SERVICE LETTER

No. 679

Piper Aircraft Corporation

Fuselage Aft Bulkhead Inspection

TYPICAL VIEW OF AFT FUSELAGE (LOOKING FORWARD)

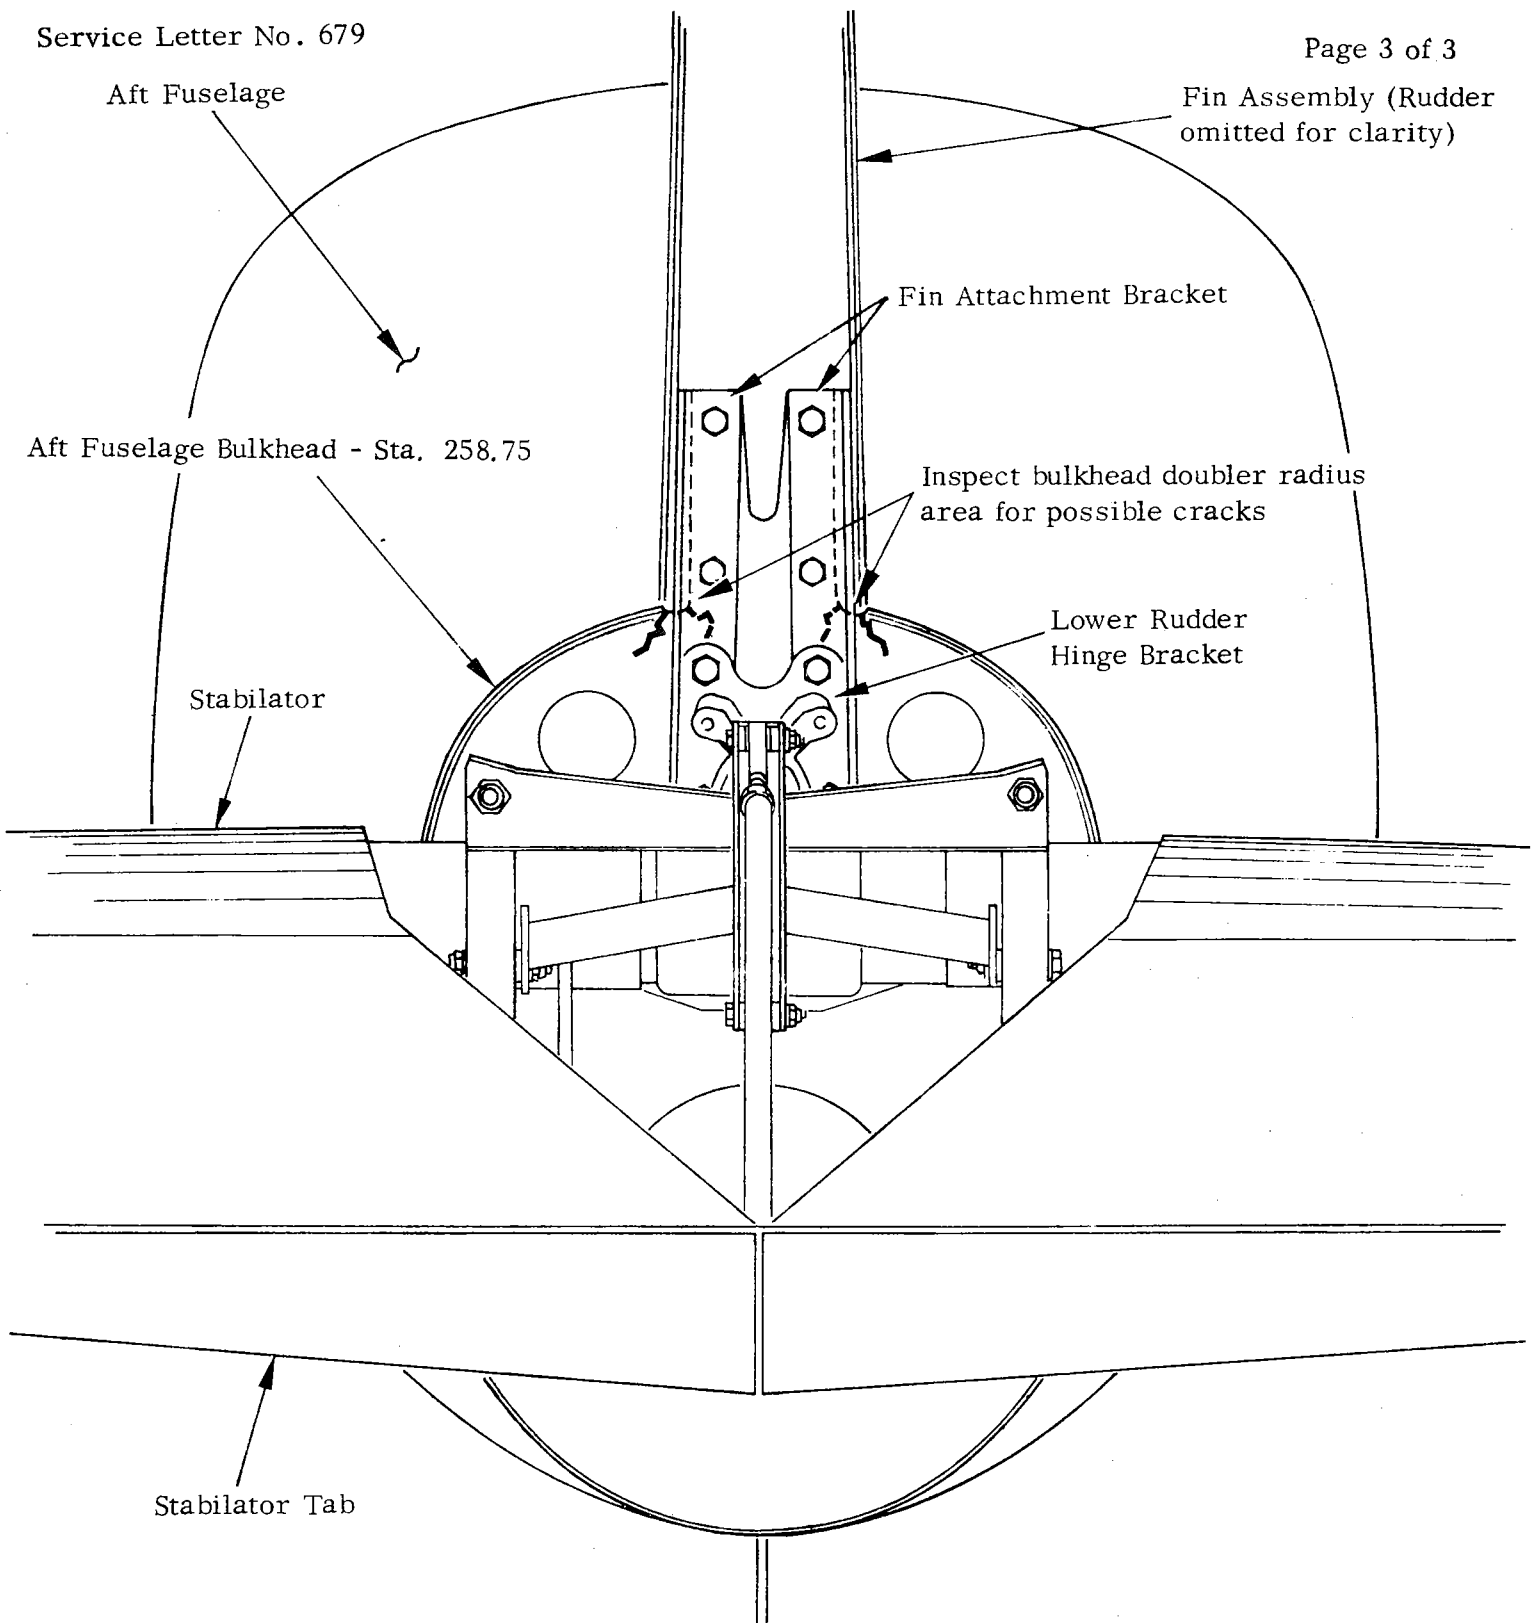
1. Remove tail cone fairing assembly from aft fuselage.
2. Carefully inspect bulkhead doubler on both sides of fin attachment brackets, as shown above, for evidence of cracks.
3. If cracks are detected, it will necessary to install the Fin Attachment Bracket Installation Kit P/N 760 783.
4. If cracks are not present, no further action is required at this time. (See Compliance Time.)
5. Reinstall tail cone fairing assembly.
